NOTICE OF DECISION

MODIFICATION OF URBAN GROWTH PRELIMINARY DECLARATION / CLASS 3 SITE PLAN REVIEW / CLASS 2 ADJUSTMENT / CLASS 2 DRIVEWAY APPROACH PERMIT / CLASS 1 DESIGN REVIEW CASE NO.: UGA-SPR-ADJ-DAP-DR23-01MOD1

LOCATION: 3470 Blossom Dr NE, Salem OR 97305

SUBJECT: **Infrastructure Memo**
UGA-SPR-ADJ-DAP-DR23-01MOD1 (25-103545-PLN)
3470 Blossom Drive NE
Blossom Apartments Modification

AMENITY SITE PLAN

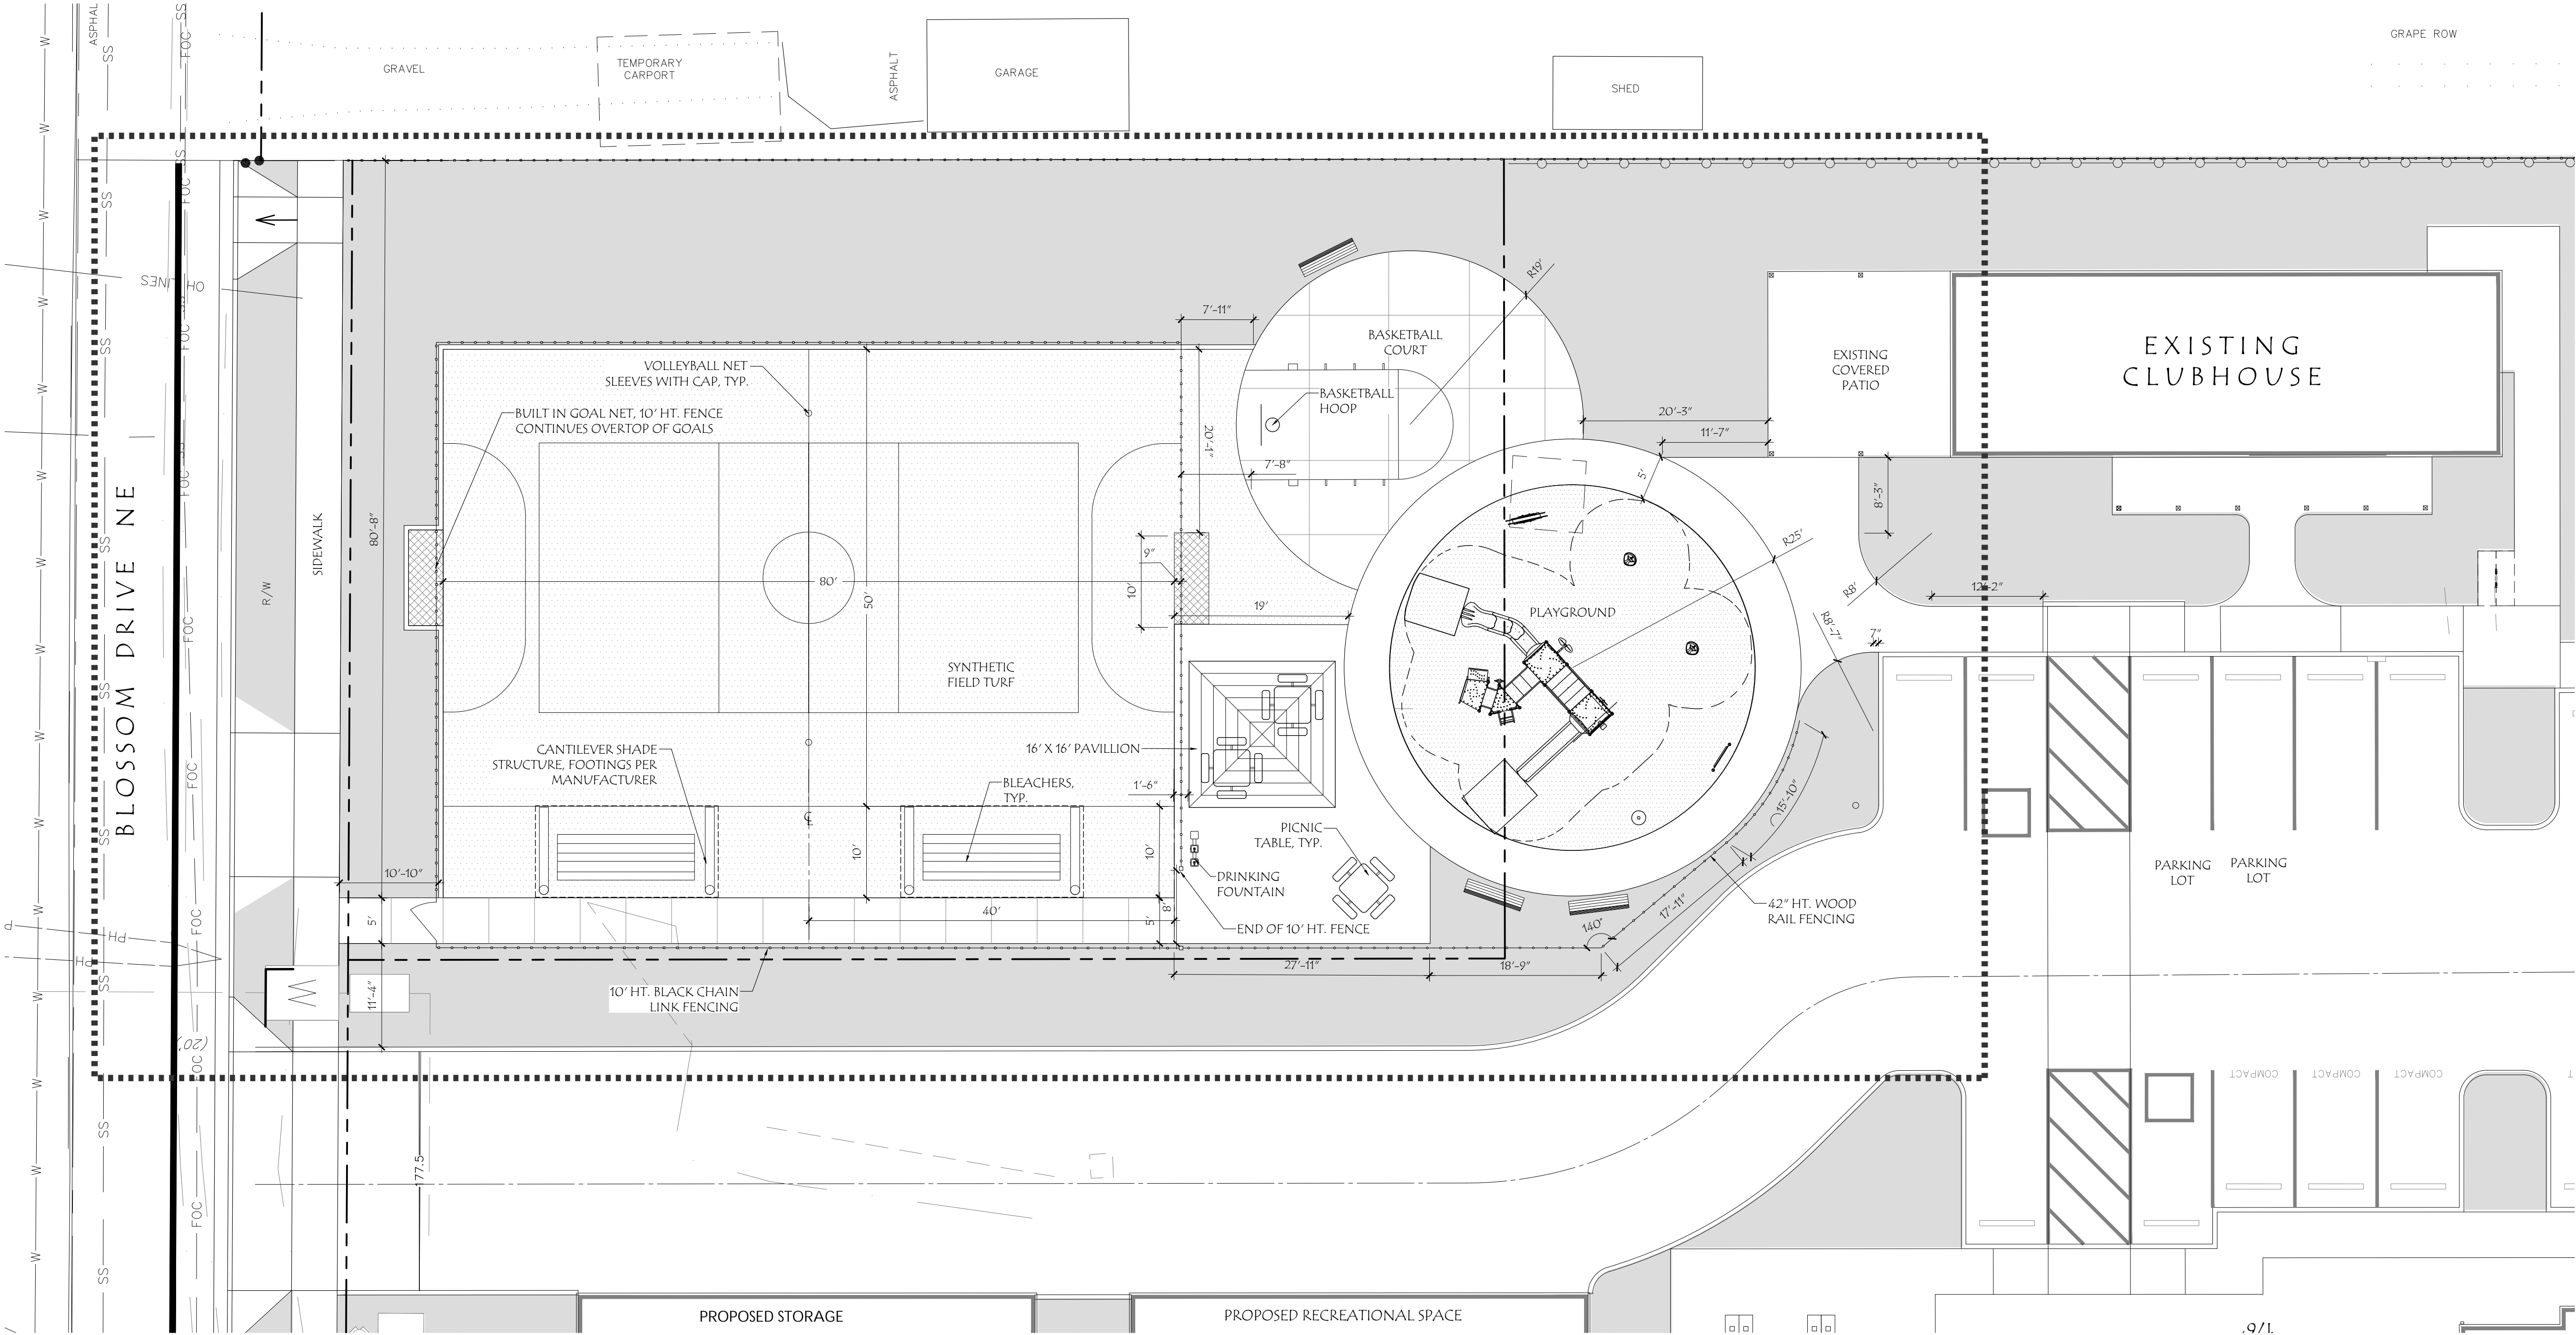
Finding: No additional lighting is shown on the provided site plans for the proposed additional open space and pedestrian pathways. Therefore, the following Condition applies:

Finding: The fencing on the provided site plans is shown to exceed the maximum height of three feet when located in the interior of the development site adjacent to the common open space and parking areas. Therefore, the following Condition applies:

Finding: The development site is served by two existing driveway approach onto Blossom Drive NE. The westerly approach is proposed to remain. However, the easterly approach on the site will no longer serve a vehicle use area. As shown on the applicant's plans, the existing parking area will be removed and replaced with the improved open space. Pursuant to SRC 804.030(b)(1) driveway approaches onto collector streets shall only provide access to a permitted parking or vehicle use area. As the driveway approach will no longer provide access to a permitted parking or vehicle use area, it shall be permanently removed. The following additional Condition of Approval is required:

Finding: The proposal includes a new fence around the proposed improved open space. Fencing is considered a vision clearance obstruction, which is not permitted under SRC Chapter 805. However, the applicant's plans show the new fence will be located outside of the vision clearance area; therefore, the Vision Clearance Standards in SRC Chapter 805 are met for the proposed modification.

Condition 3: At the time of building permit review, adequate lighting must be shown for the proposed pedestrian paths.

Condition 4: At the time of building permit review, all interior fencing adjacent to common open space and outdoor community amenities shall have a maximum height of three feet, unless a Class 2 Adjustment is approved.

Condition 5: The applicant shall permanently close the unused driveway approach (easterly approach) onto Blossom Drive NE and replace with curb, a landscape strip, and sidewalk.

PROPOSED PLANTING PLAN

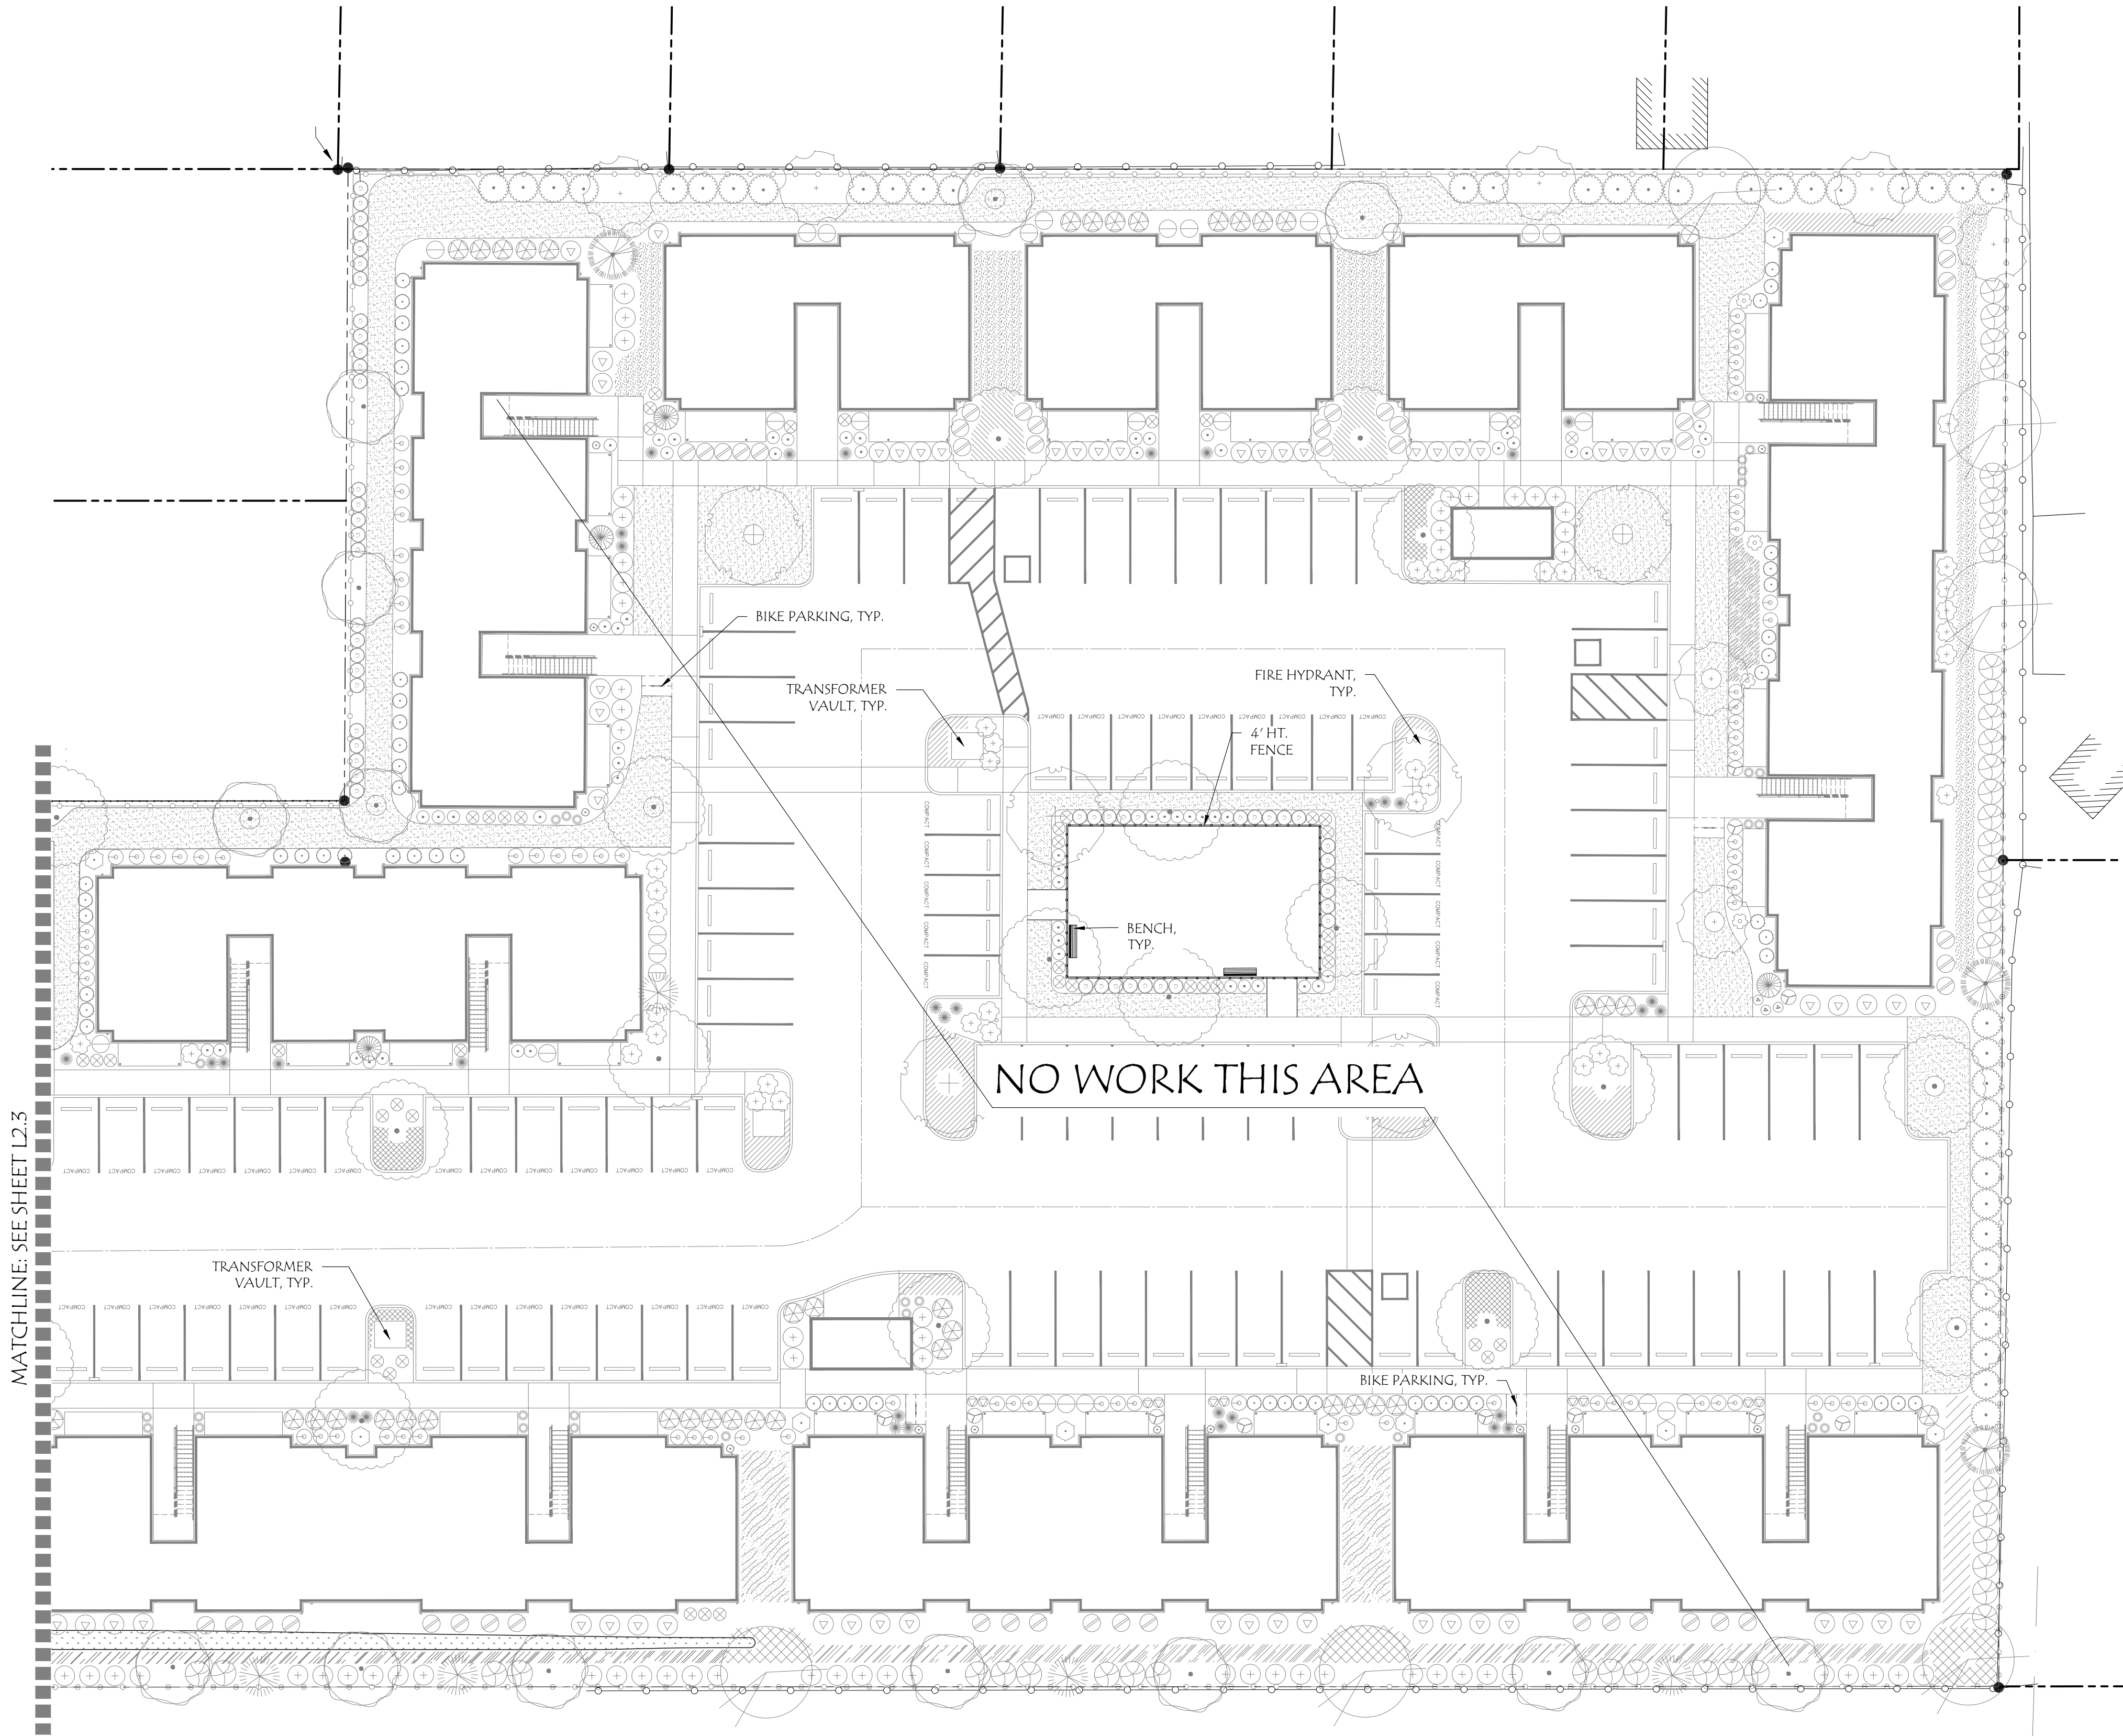
Finding: The Property Line Adjustment will modify the street-abutting setback and interior side setback on the northeastern part of the property, requiring additional landscaping. A minimum 12-foot setback with Type A landscaping is required from the street-abutting property line, and when abutting Residential Zones, a minimum ten-foot setback with Type C landscaping is required from the interior side property line. Therefore, the following Conditions apply:

planted as part of the original approval based on a site area of 3.25 acres. Per the applicant's site plans, 95 trees are proposed, meeting the standard.

Condition 2: Setbacks along the adjusted property lines per PLA25-11 shall be landscaped with Type A landscaping along the street-abutting property line, and Type C landscaping along the interior side property line when abutting Residential Zones.
